This software updates or alters the functions and features noted below. The instructions and information that follow are meant as a supplement to the original instruction manual that accompanied the transmitter. Please refer to the original instruction manual where applicable, but replace the steps indicated below with these instructions. Please check to ensure that the update has been installed.

V3.10

V3.9

1. Add Model ID

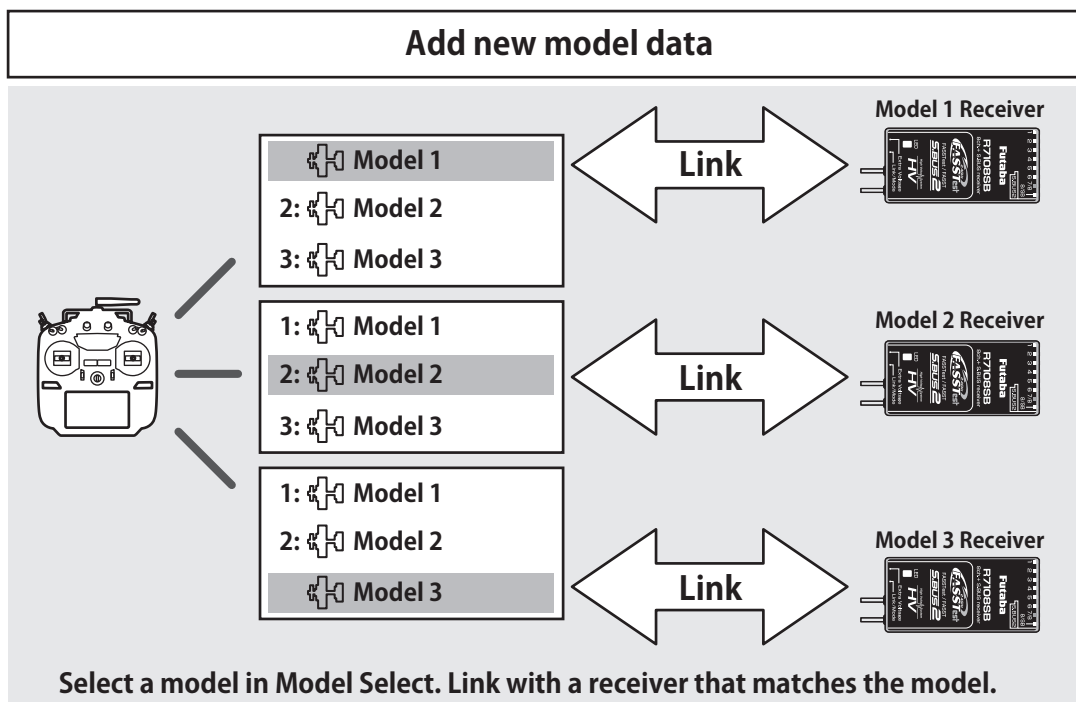
As an added level of safety in the form of Model ID, which will prevent the accidental control of a model when using a different model data by preventing link.

In Ver 3.9 or later software with the model ID function added, model data saved on the SD card cannot be called using the model select function. To use the model data of the SD card, copy the model data to the transmitter. If the model data of the SD card was selected before the update, an error message will be displayed at the first startup after the update, and the model will automatically switch to the model data of the transmitter.

Link is required when a new model is made from a model selection.

When using R3004SB

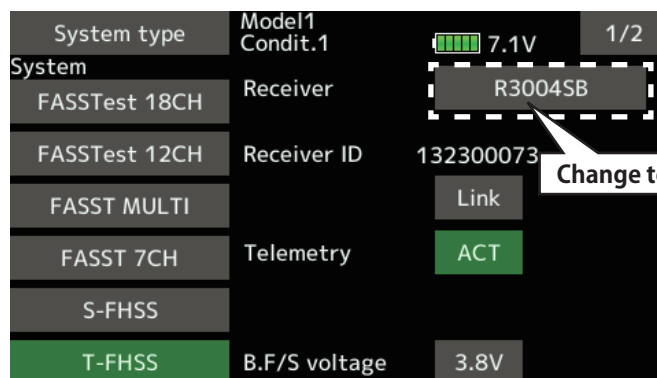
■ When using the **R3004SB**, set "Receiver" in the system type screen T-FHSS mode setting to [R3004SB]. When using other T-FHSS compatible receivers, set "Receiver" to [Normal].

⚠ R3004SB receiver does not support model ID function.

◆ Speed sensor screen

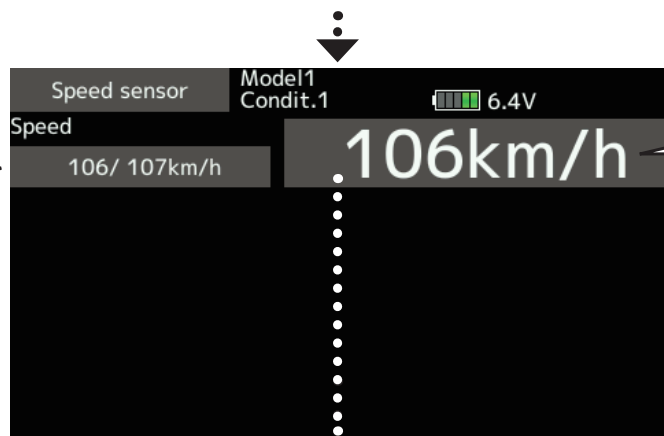
Max. and min. values since the power was turned ON will display.

◆ Alarm setting

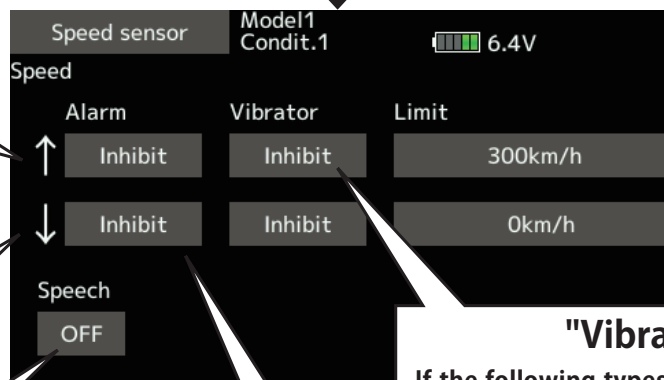
↑ An upward arrow indicates the alarm will sound when the speed reaches above your set value.

↓ A downward arrow indicates the alarm will sound when the speed reaches below your set value.

The ON/OFF switch of Speech is chosen.

A setup of the speed on which the alarm operates.

Alarm is chosen from Buzzer, Voice, and Inhibit.

"Vibrator" type

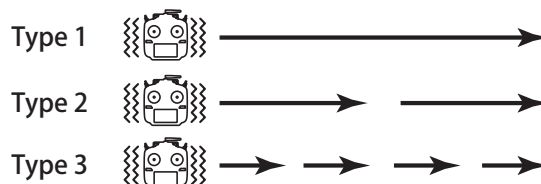
If the following types are selected, the transmitter will vibrate during the warning.

2. CRSF Protocol for TBS

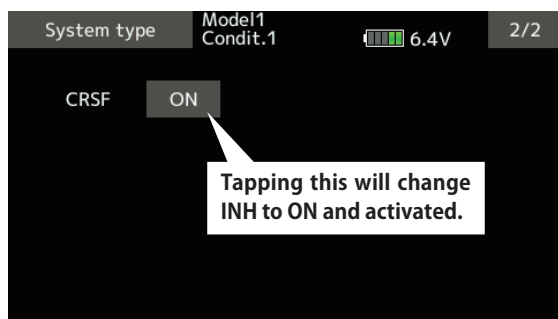
The T18SZ/T16SZ/FX-36 has been made compatible with the CRSF (TBS) protocol.

- ① [Linkage menu] → [System Type] → [Page 2/2] is opened from the transmitter.

- ② Tap the "CRSF" button to [ON]. A signal conforming to the CRSF standard is output from the S.BUS setting connector (S.I/F) of the transmitter.

Sensor type selection screen

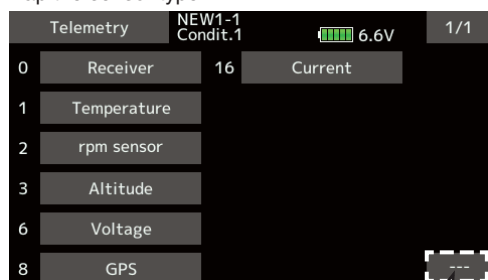
You can choose which type of sensor to displays. Tap the sensor type.

If you do not want to display telemetry data on the telemetry monitor screen, select "---".

4. Data Converter

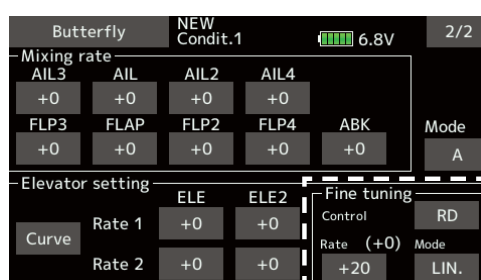
FX-30 and T12FG have been added to the data converter compatible models.

The transmitter name is displayed on icon.

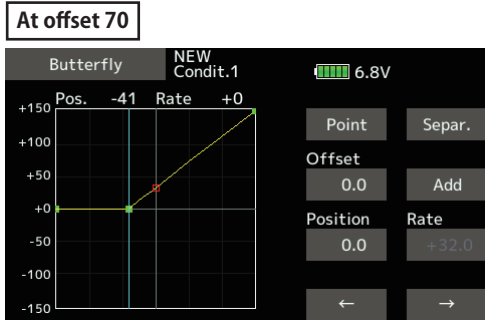
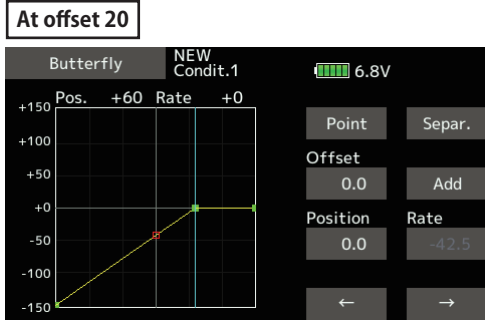
- **Mode A**
(Normal)
- The butterfly operation direction is reversed at the neutral position (50%) of the throttle stick.

The direction of butterfly motion is reversed.

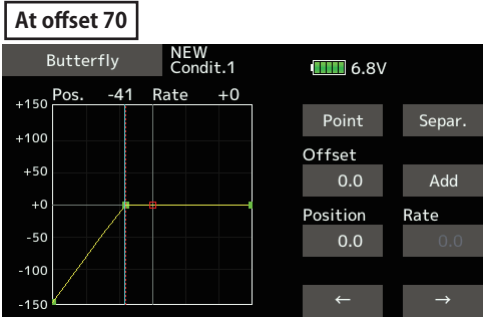
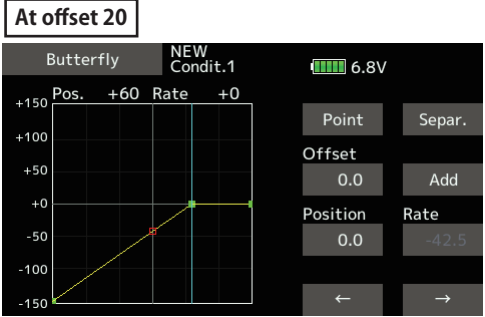
- **Mode B**
(Throttle stick full stroke MODE)
- It does not reverse at the neutral position, so you can set the butterfly operation start point with the full stroke of the throttle stick.

The direction of butterfly motion is not reversed.
